Closeout Presentation

Director's Independent Design and CD-2/3 Review of the Muon g-2 Project

June 17-19, 2014

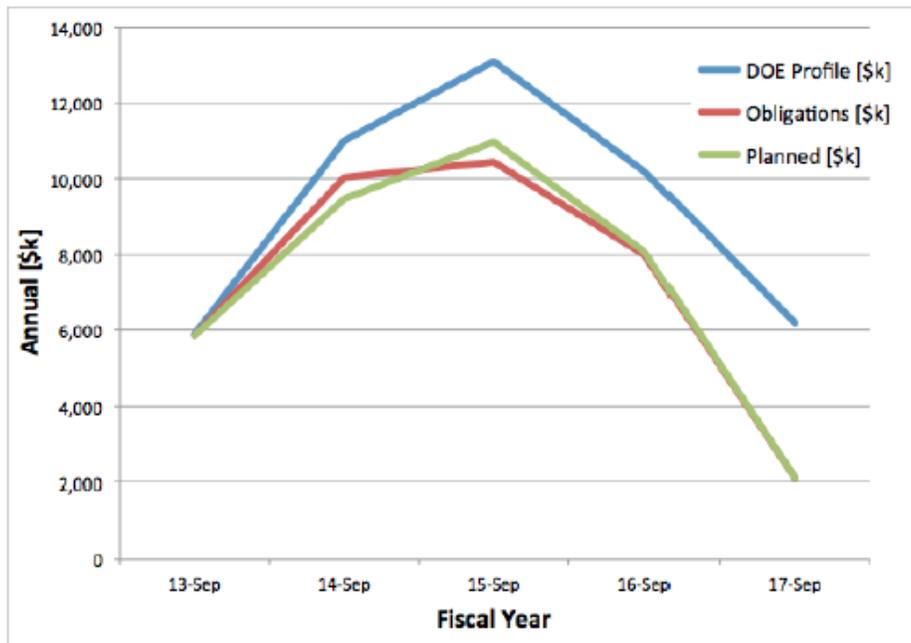
The Project presented the BO vs BA curve which is provided below.
